ADDENDUM 4

Section 3, Scope of Work, Subsection 3.8, Ornamental Steel Fencing Requirements, is amended as follows:

3.13.3 Wrought Iron Fencing (PED) Panels

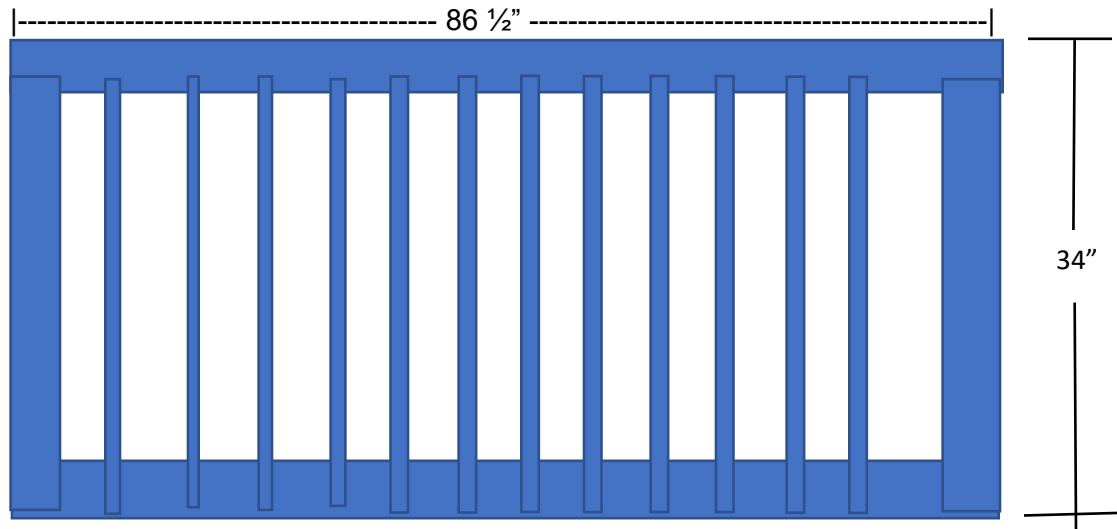
- A. Build and deliver the requested wrought iron fence panels according to the specifications (for use in pedestrian crossing islands throughout the City) and

- a. All panels shall be powder-coated black.
 - b. Horizontal top and bottom rails will be constructed using 1" square tubing, 16 gauge.
 - c. Vertical sides should be constructed using 1" square tubing, 16 gauge.

- d. Vertical inner pickets of 5/8" square tubing shall be constructed, 16 gauge at 4 1/2" spacing.
 - e. Panels shall be 86 1/2" W x 34" H
 - f. Corner ends must be built according to the drawing below.
